UNITED STATES
NUCLEAR REGULATORY COMMISSION

SUBJECT: FEBRUARY 6-7, 2003, MEETING SUMMARY: MEETING WITH DUKE
COGEMA STONE & WEBSTER TO DISCUSS MIXED OXIDE FUEL
FABRICATION FACILITY REVISED CONSTRUCTION
AUTHORIZATION REPORT

**MEETING SUMMARY
MOX FUEL FABRICATION FACILITY
February 6-7, 2003**

Azide System Analysis

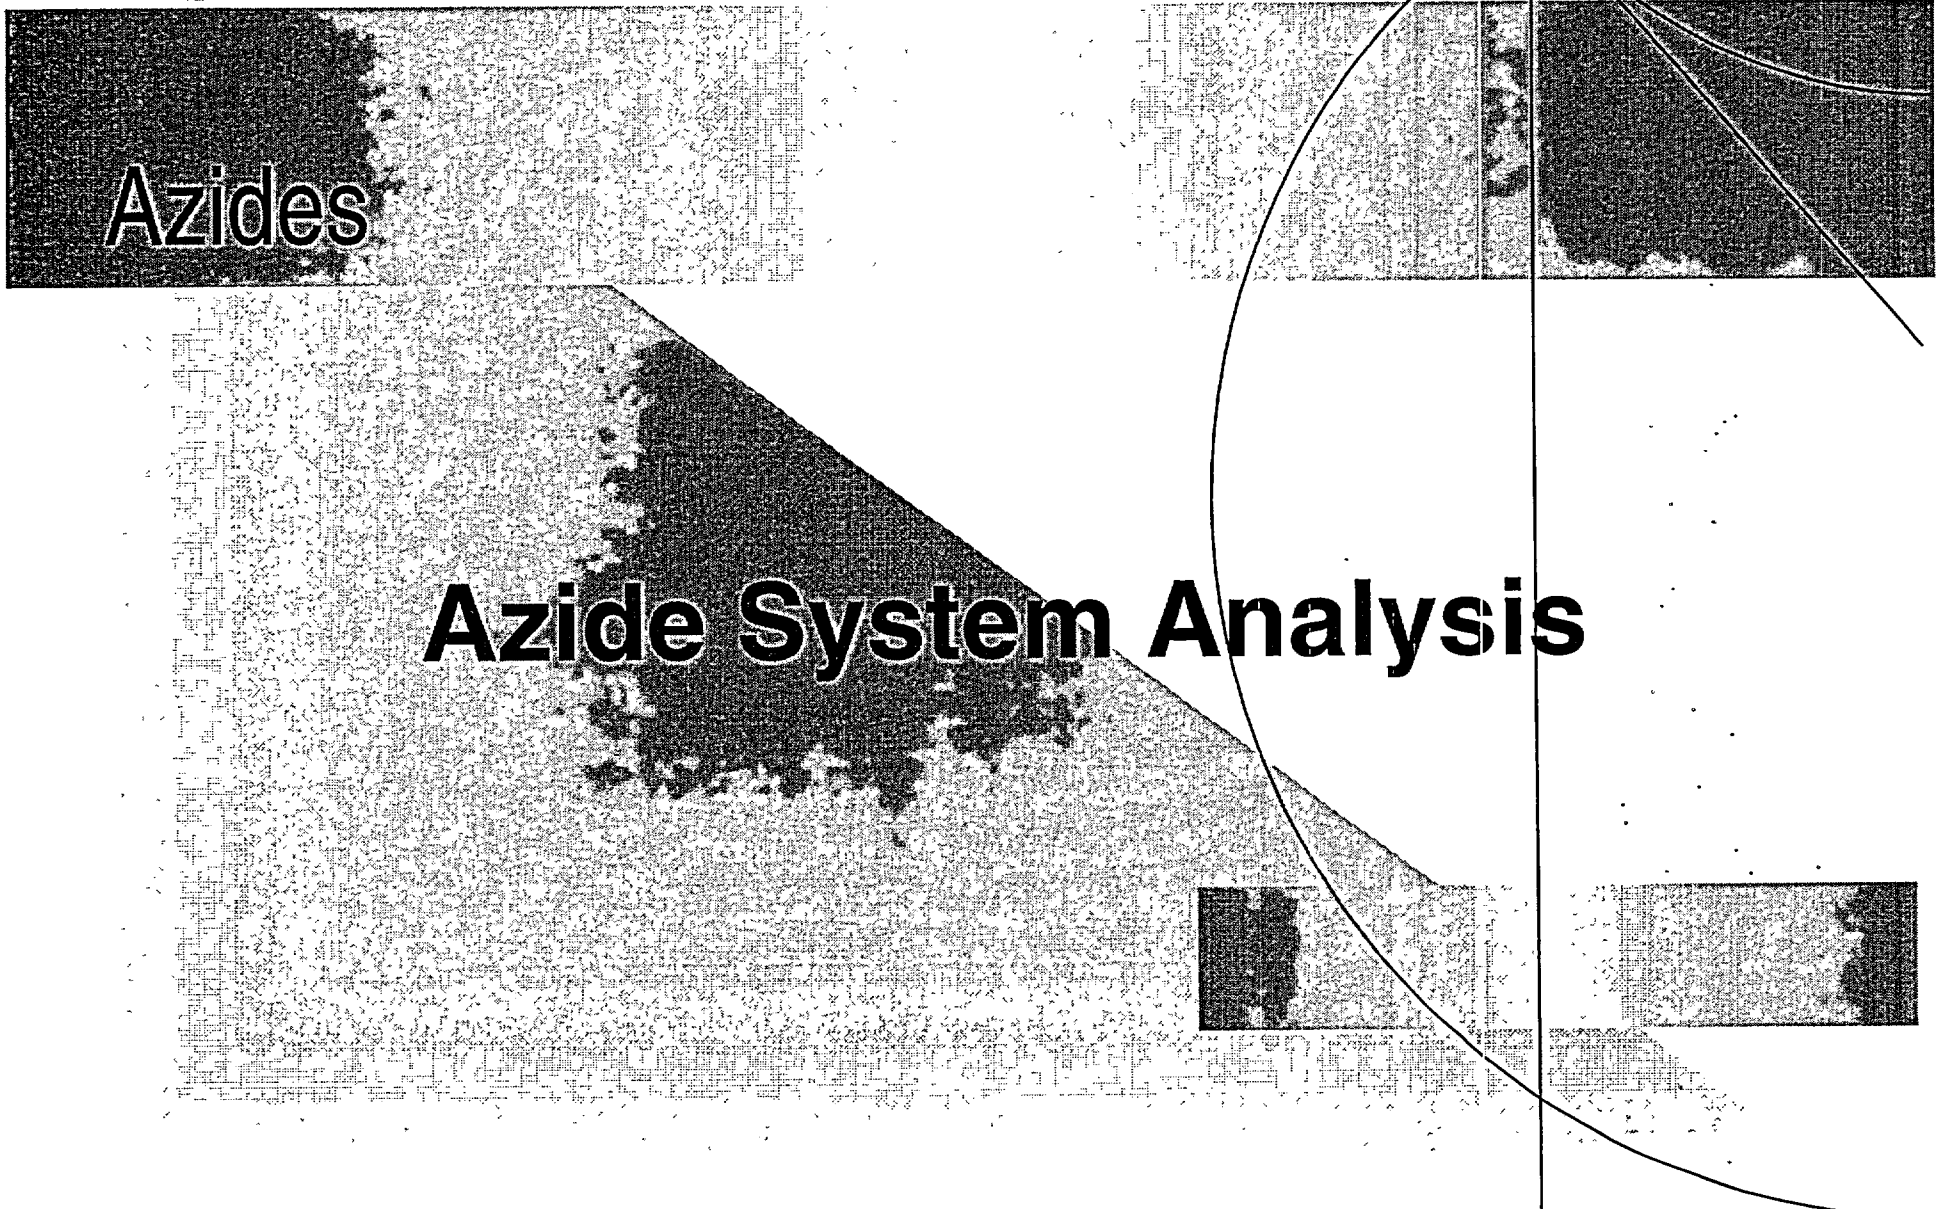
5. Azides (CS-04)

DCS discussed the safety concerns associated with azides. While electropositive metal azides, such as NaN_3 are not explosive, they can aid in the evolution of hydrazoic acid. For other azides, dry out conditions can result in an explosive hazard. The DCS approach will be to prevent the formation of metal azides and their exposure to dry conditions and high temperatures. Administrative procedures, leak detection and avoidance of dryout conditions will be utilized on that portion of the process downstream of the stripping columns where hydrazine is used. The aqueous phase, which is most likely to contain any azides, is sent to the oxidation column. Prior to movement into the oxalic acid portion of the process, samples are taken to assure that no Pu(III) is present. The absence of Pu(III) is an indicator that the oxidation process is performing correctly and no azides will be present. However, if any Pu(III) is detected, then the oxidation process has not performed as expected and azides may be present. This strategy prevents the possible introduction of azides into the downstream evaporator.

Any azides in the organic phase will end up in solvent recovery where NaN_3 is produced in bulk to eliminate residual hydrazoic acid.

It is conceivable that azides could be formed in the liquid waste recovery unit. DCS noted that they would revise Chapter 8, page 8.34 to better describe the process.

- ◆ Azides present a potential risk in dry conditions
- ◆ DCS Safety Strategy is to avoid dry-out conditions:

Tanks in the purification process that may potentially contain azides are rinsed after draining / leakage

- ◆ Avoid Dry-out conditions
- ◆ Limit the locations where U/Pu azides may be present so as to avoid high temperatures e.g. restrict azides from entering evaporators or furnace (sampling controls for azides have previously been identified as principal SSCs in the CAR)

The CAR will be revised to indicate sampling in a Liquid Waste Reception Unit to confirm destruction of azides.
